National Bureau of Standards

REPORT

SUGGESTED METHOD FOR REPAIR OF ROOF SLAB
GENTILE AIR FORCE BASE

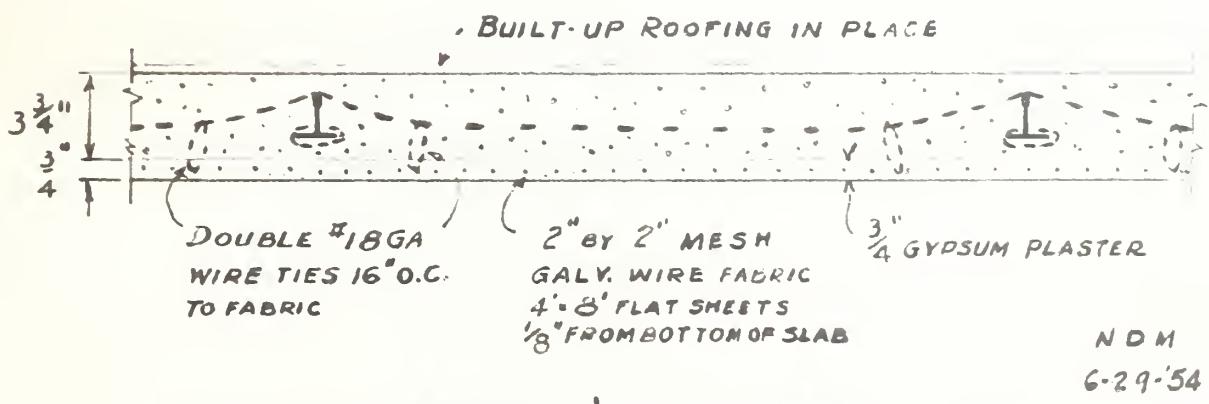
A method for the repair of panels which show signs of disintegration is suggested by the sketch herewith. Holes would be drilled into the slab from below at 16 in. centers so as to expose 1 in. strands of the wire fabric reinforcement. No. 14 gauge galvanized tie wires would be doubled and looped over the strands of the reinforcement, or in lieu of ties No. 12 bare wire hooks. Two-by two-in. mesh wire fabric would be tied to the effect of the damaged slab and furred down at least 1/8 inch to provide for embedment of the wire fabric in plaster. Three fourths inch thick sanded gypsum plaster applied to the bottom of the deck slab, when so reinforced by wire fabric, will be sufficient to support the weak perlite gypsum concrete and provide cover to the tee irons to give two-hour rating for the assembly. The plaster mix should be 1 part gypsum cement extra fibered to 2 parts by weight of clean sharp sand. The scratch coat should be applied as thick as will adhere. The second coat should be applied as soon as it will stay in place, preferably before the scratch coat has set and given a sand float finish.
